DESCRIPTION OF DIFFERENCES

between ORIGINAL and SIMILARITY

Name of Appliance : 1.9GHz Cordless Telephone System
SIMILARITY Model No. : KX-TGM420 (Base Unit)
FCC ID: ACJ96NKX-TGM420
ORIGINAL Model No. : KX-TGM430 (Base Unit)
Approval Date : under application
FCC ID: ACJ96NKX-TGM430

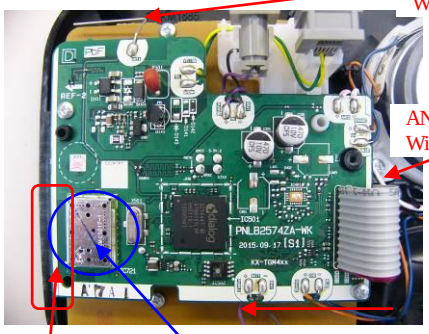
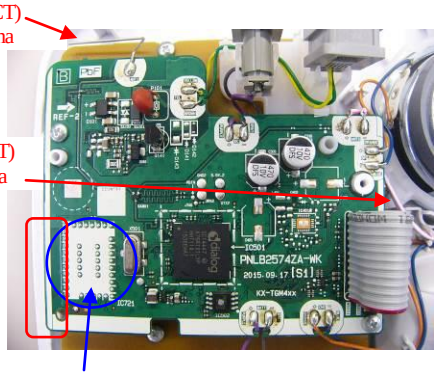
BASIC MODEL	SIMILAR MODEL
	KX-TGM430	KX-TGM420
Appearance		Not provided with Bluetooth function
Inside Structure	ANT1 (DECT) Wired antenna ANT2 (DECT) Wired antenna BT Antenna are formed in the P.C. board.

ANT1 (DECT) Wired antenna ANT2 (DECT) Wired antenna BT Pattern antenna Bluetooth module

Bluetooth module is removed. P.C. board and Antenna are identical.	
AC adaptor	Both model are used to PNLV226 AC adaptor.
